# City of Boulder Planning

## MEMORANDUM TO THE LANDMARKS BOARD

### Landmark Alteration Certificate Request

Public hearing and consideration of a proposal to demolish a non-contributing house and accessory building construct a new 3,295 sq. ft. house and 400 sq. ft. two-car detached garage at **406 Pearl Street** located in the West Pearl Historic District pursuant to Section 9-11-18 B.R.C. 1981 (HIS2020-00163) and under the procedures prescribed by chapter 1-3, "Quasi-Judicial Hearing," B.R.C. 1981.

Figure 15. Detail of 1949 Photo of house (left) Proposed North (Pearl Street) Elevation (right).

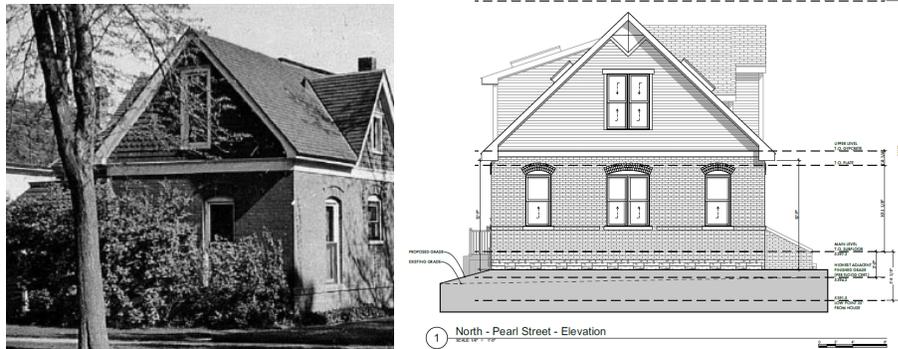
- b. Determine the appropriateness of metal roofing elements and use of stone on new garage by studying precedence in the district;
  - c. Explore locating the main entrance of the house on the north elevation (facing Pearl Street), increasing the space between the historic barn and garage and change the stone facing on the garage to wood siding;

- **2.1 Building Location, Orientation & Spacing**
  - Proposed house location appropriate, but that main entrance should be from the front (Pearl Street) of the house as suggested above.

Figure 16. Proposed West (4<sup>th</sup> Street) Elevation.

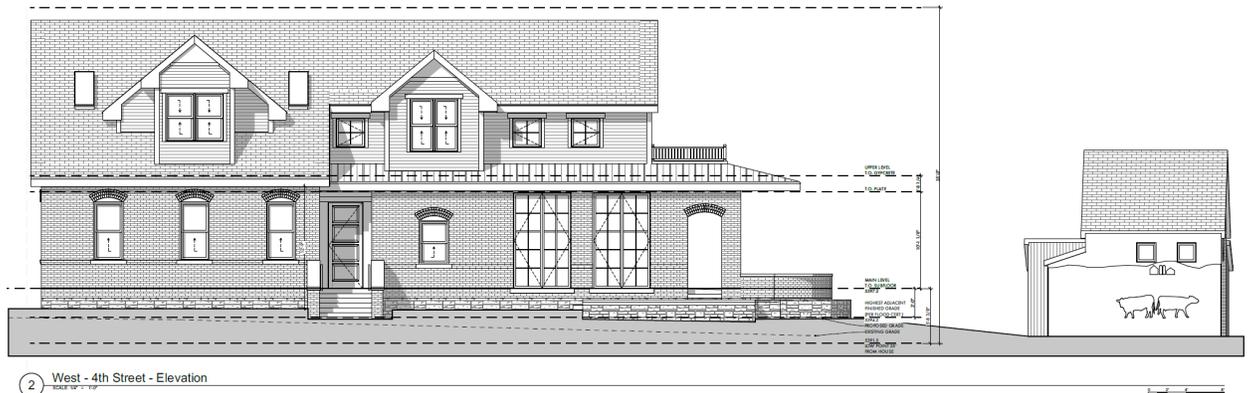
- **6.5 Key Building Elements**
    - Fenestration on front portion of proposed house generally reflects traditional window patterns though over-scaled windows and doors especially at west and south elevations should be revised.

|           | Guideline                                                                                                                                                                                                                                                    | Analysis                                                                                                                                                                                                                                                                                                                                                                                                                                                                                                                                                                                             | Conforms? |
|-----------|--------------------------------------------------------------------------------------------------------------------------------------------------------------------------------------------------------------------------------------------------------------|------------------------------------------------------------------------------------------------------------------------------------------------------------------------------------------------------------------------------------------------------------------------------------------------------------------------------------------------------------------------------------------------------------------------------------------------------------------------------------------------------------------------------------------------------------------------------------------------------|-----------|
| 8.        | Strongly horizontal or vertical facades should be avoided unless they are compatible with the character of the structures in the immediate area.                                                                                                             | Large vertical openings (especially on west and south faces of house) should be revised. Review at the Ldrc.                                                                                                                                                                                                                                                                                                                                                                                                                                                                                         | Maybe     |

Figure 18. Proposed South (rear) Elevation.

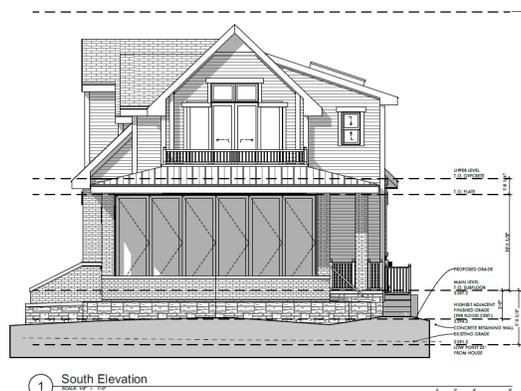
- a. Redesign of the proposed house to significantly reduce the size and redesign of the rear porch and deck to have a more open railing system, redesign of fenestration on the south portion of the west elevation and south elevation to be more traditionally scaled and proportioned, and eliminate the west facing skylights;

- Reduction to rear porch/deck size and configuration should also include revisions from brick to lighter wood railing Details of upper porch railing not submitted – resolve at the Ldrc.

Figure 19. Proposed Garage South (alley) and East (side) Elevations.

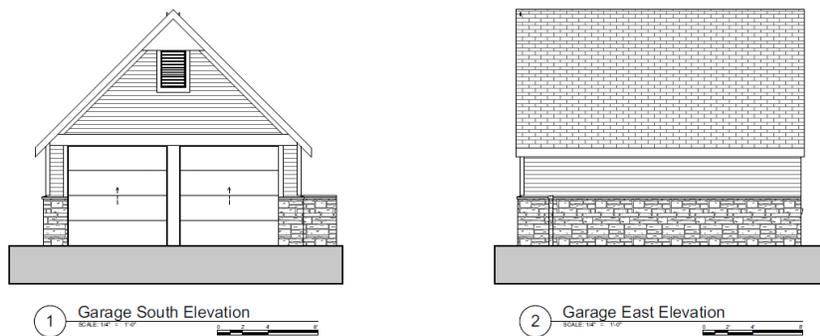
- Proposed materials including stone, brick, and clapboard all traditionally found in the historic district, though staff considers that use of stone on garage inappropriate.

- Proposed garage is shown to be located at rear of lot and is smaller and simpler in design than the main house and historic barn but should not be sided in stone.
- Staff considers that space between barn and new garage should be increased to extent possible. Resolve at Ldrc.

Figure 21. Proposed garage relative to contributing barn

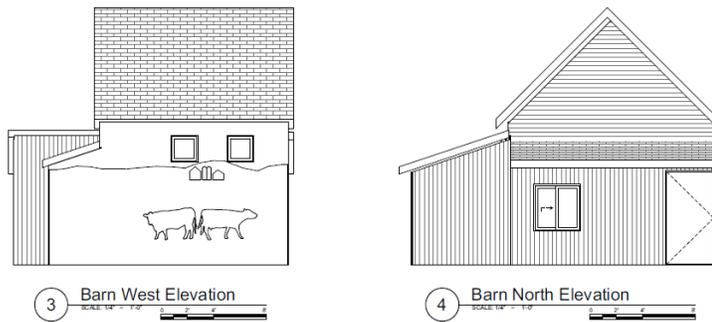
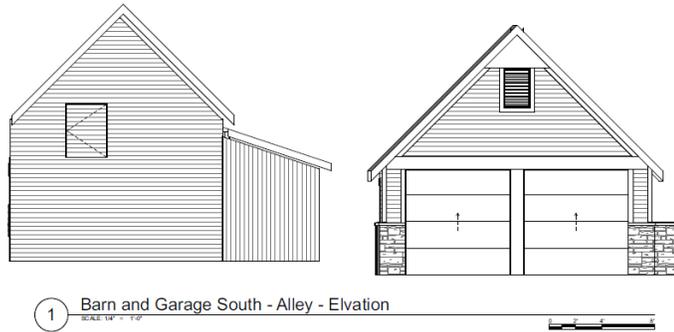
- Distance between rear porch/deck significantly increased to provide more rear garden space as suggested above.
  - Distance between the contributing barn and proposed garage should be increased to extent possible.

- Proposed garage is shown subordinate to and compatible with proposed main house, but consideration should be given to increasing distance between it and historic barn.
